Technical Service Bulletin

91 Sound system: A-pillar speaker rattle, vibration or poor audio reproduction

91 20 45 2059143/2 December 16, 2020. Supersedes Technical Service Bulletin Group 91 number 20-55 dated April 8, 2020 for reasons listed below.

Model(s)	Year	VIN Range	Vehicle-Specific Equipment
A6, A7	2019	All	Not Applicable

Figure 1. Unwanted noise at the A-pillar speaker's electrical connection.

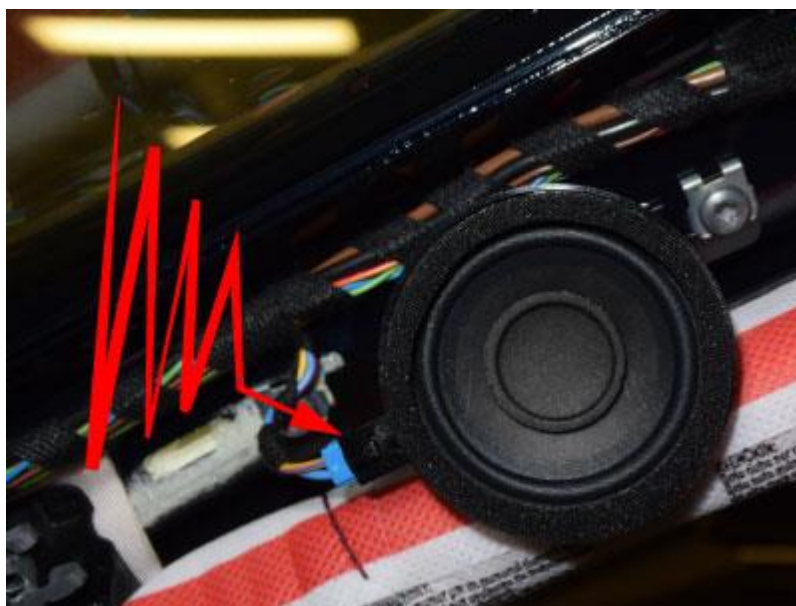
Tolerance between the speaker and harness connector is too high, creating unwanted vibration.

1. Verify that the noise is coming from the electrical connector at the A-pillar speaker (R276 or R277) (Figure 1).

2. Ensure fasteners are properly torqued to 3.0Nm.
3. Replace the connector at the speaker with the improved connector 4B0 971 832 A.
